Memorandum

Date: July 23, 2021

Project #: 10865.03

Re: Riverside Supplemental Stormwater Memo for Revised Stormwater
Management Design

vhb Proposed Drainage Conditions
Riverside Station
Grove Street
Newton, Massachusetts

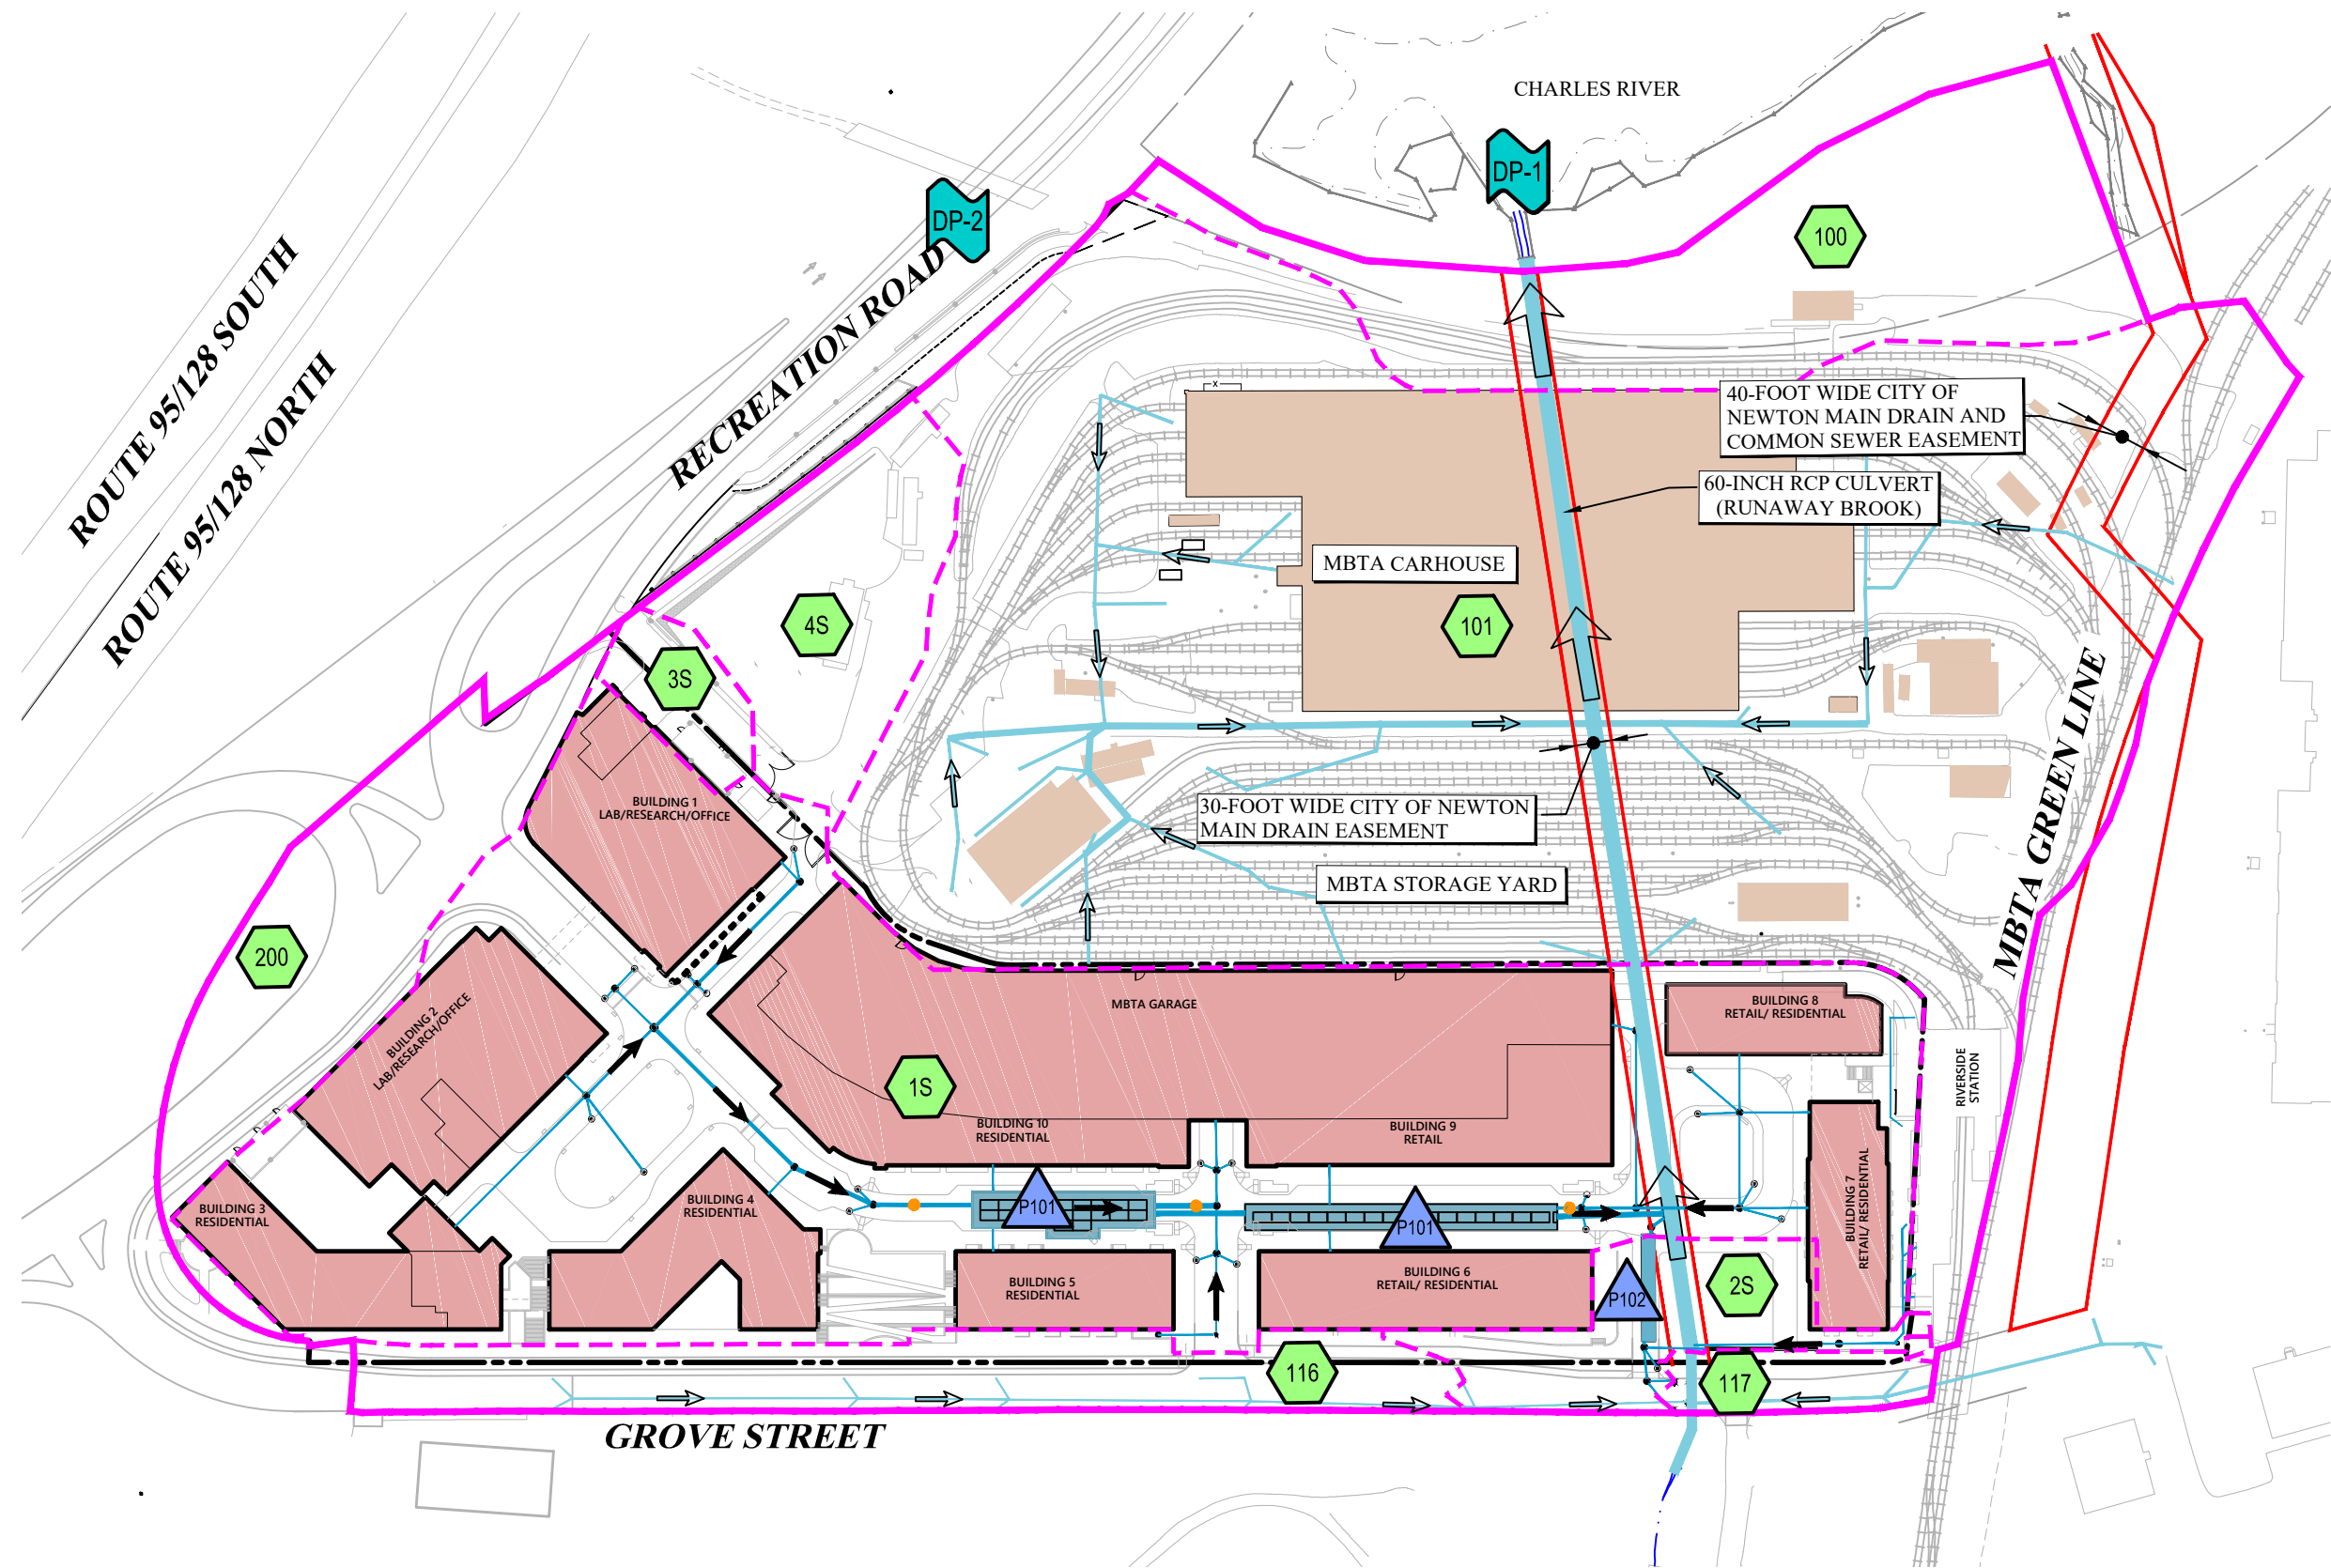
As the proposed MBTA garage design advanced, it was determined that a subsurface infiltration system was no longer feasible to be located with the garage footprint without conflicting with the garage's foundation, thus the system was relocated to be within the pavement limits of Main Street. This allowed the garage to be designed without a subsurface infiltration system restricting space and locating the system within the roadway limits impact to the proposed landscaping along Main Street. Relocating the infiltration system allowed for a system with more chambers and a greater storage capacity. System P101 is split into two fields, Field A and Field B, connected by a 48" HDPE pipe. Field A is located between Buildings 5 and 10, where the existing soil conditions allow a high infiltration rate. Field B is located between Buildings 6 and 9, where the existing soil conditions have a low infiltration rate. Field B will provide additional storage for the stormwater runoff to be collected and retained prior to recharging through Field A or discharging to the existing City of Newton 60-inch culvert for larger storm events. The system is comprised of StormTrap Doubletrap units that are approximately 6.0-feet tall and allows the stormwater to be recharged. A weir is

located at the northern end of Field B, which mitigates the collected runoff to allow the water quality storm volume to fully infiltrate. Sanborn Head determined the infiltration rate to be 8.27 in/hr, based on Sanborn Head’ test pit SH-205 underneath Field A. The bottom of system P101 at elevation 53.0 is greater than four-feet above the ESHGW. Based on Sanborn Head’s analysis, ESHGW is at elevation 45 and elevation 46, thus a mounding analysis is not required. Stormwater runoff conveyed to the StormTrap Doubletrap system is pretreated using three WQUs, located at the inlets to the system. Subsurface infiltration system P102 has remained unchanged.

Figure 3, *Proposed Drainage Conditions*, illustrates the proposed drainage conditions for the Project, including the revised building footprints, Road A layout, and relocation of subsurface infiltration system P101, is attached to this memorandum. A revised version of the previously presented in Table 2 provides a summary of the updated proposed conditions hydrologic data.
